Sent: 27/04/2021 3:15:16 PM
Subject: 12 Ponsonby Parade Seaforth NSW 2092 DA 2021/0008 WRITTEN
SUBMISSION: LETTER OF OBJECTION #2 Submission: Wheeler
Attachments: Wheeler Submission 270421 Amended plans.docx;

a written submission by way of objection to DA 2021/0008

Re:
12 Ponsonby Parade Seaforth NSW 2092
DA 2021/0008

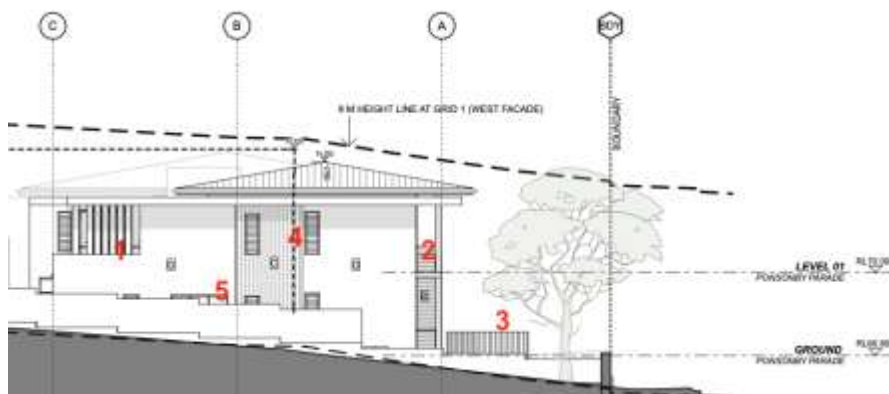
We continue to be concerned regarding the continuous 'block' forms over 33m long, rather than multiple pavilions to break up the mass, and to respond better to neighbour's dwellings. The ground floor is positioned 2.8m above street level, presenting a significant 4m walled frontage to the streetscape.

We continue to be concerned on the excessive FSR that is proposed.

Applicant's Overshadowing Diagram: Our dwelling at the top left corner

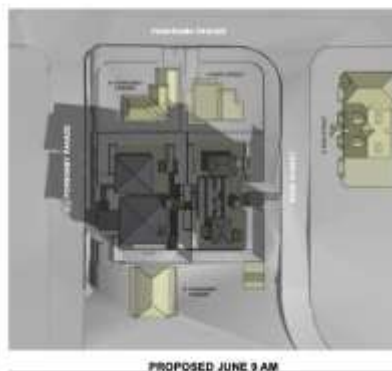
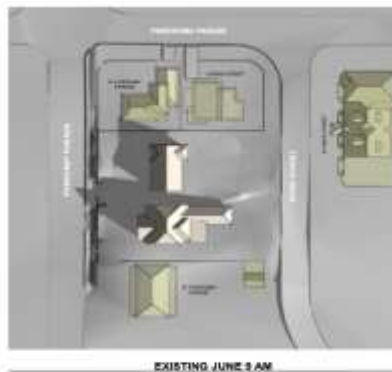
We are concerned to the additional overshadowing in the winter mornings. The applicant's overshadowing drawing clearly shows the loss at 9am at Winter.

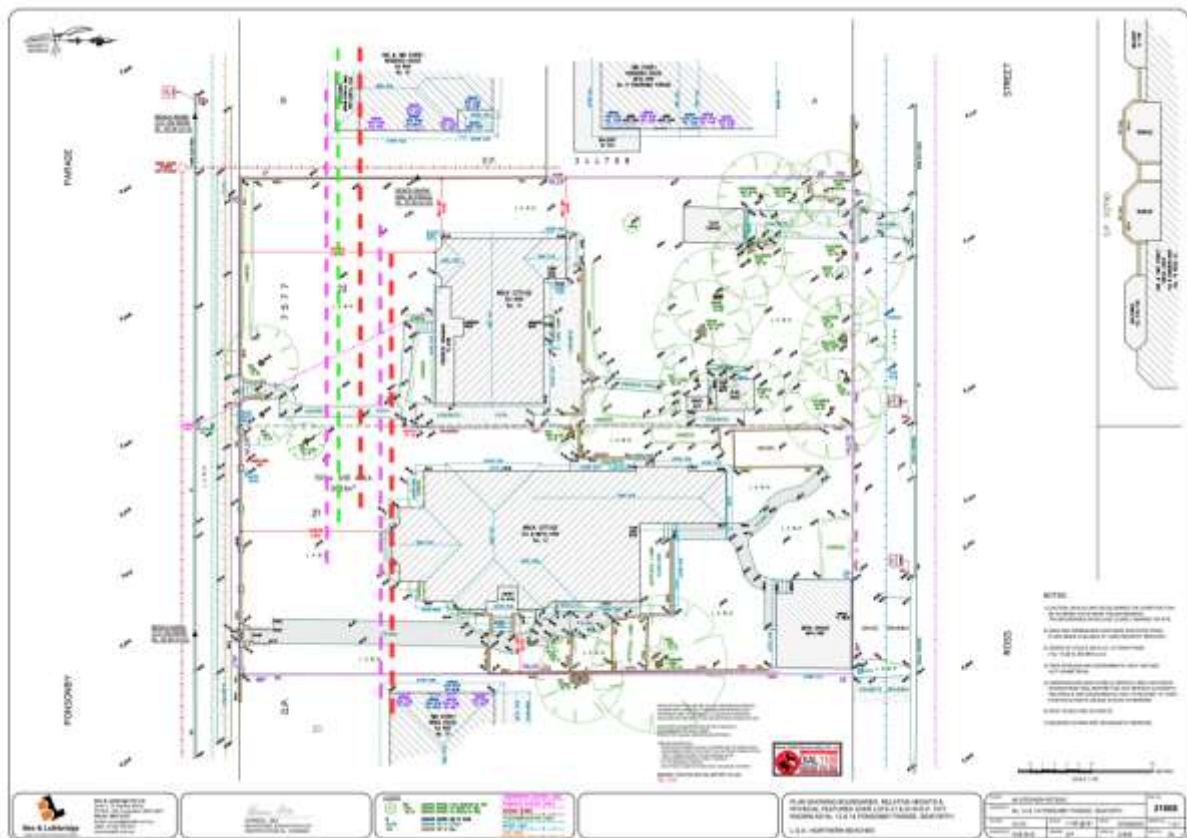
6. **Lack of modulation and raised plinth.** Continuous 'block' forms over 33m long, rather than multiple [four] pavilions to break up the mass, and to respond better to neighbour's dwellings. The ground

floor is positioned 2.8m above street level, presenting a significant 4m walled frontage to the streetscape.

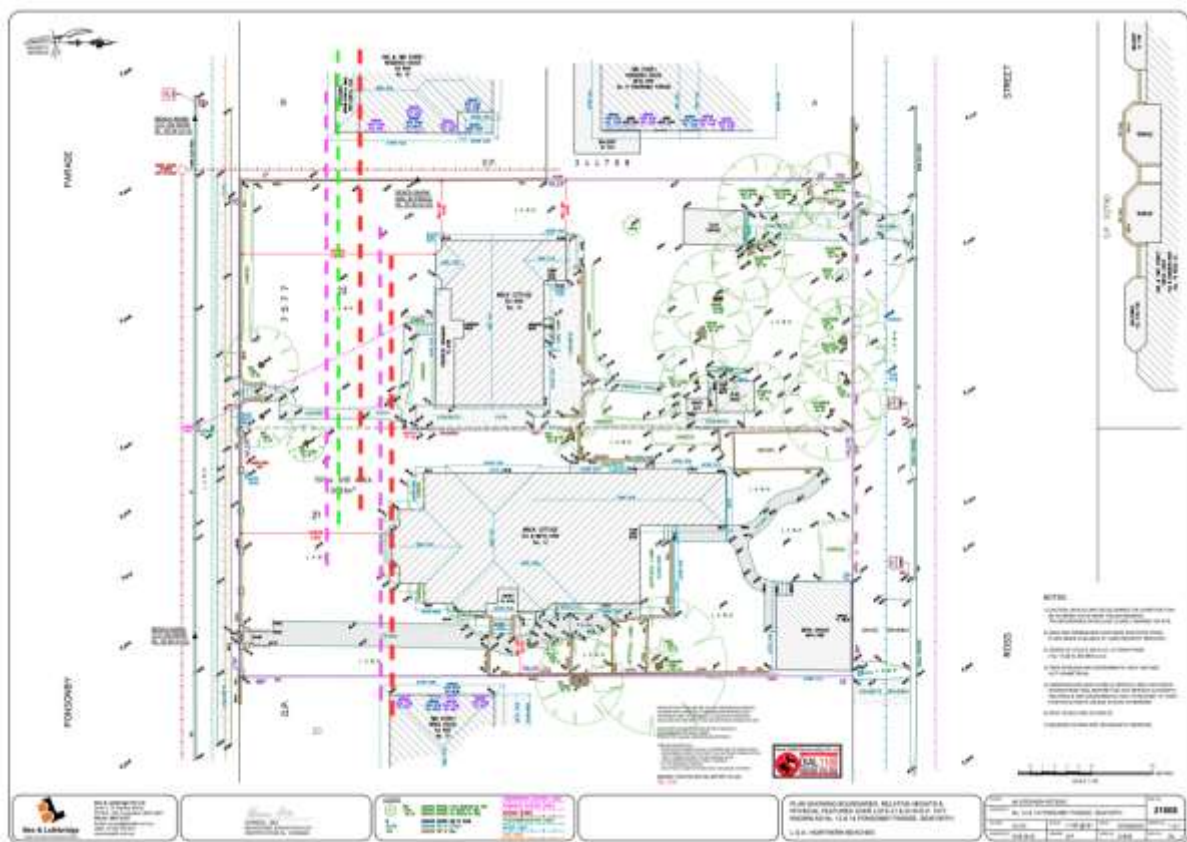
We contend that the proposed dwelling must align with our external wall zones of our dwelling and that of our neighbours dwelling.
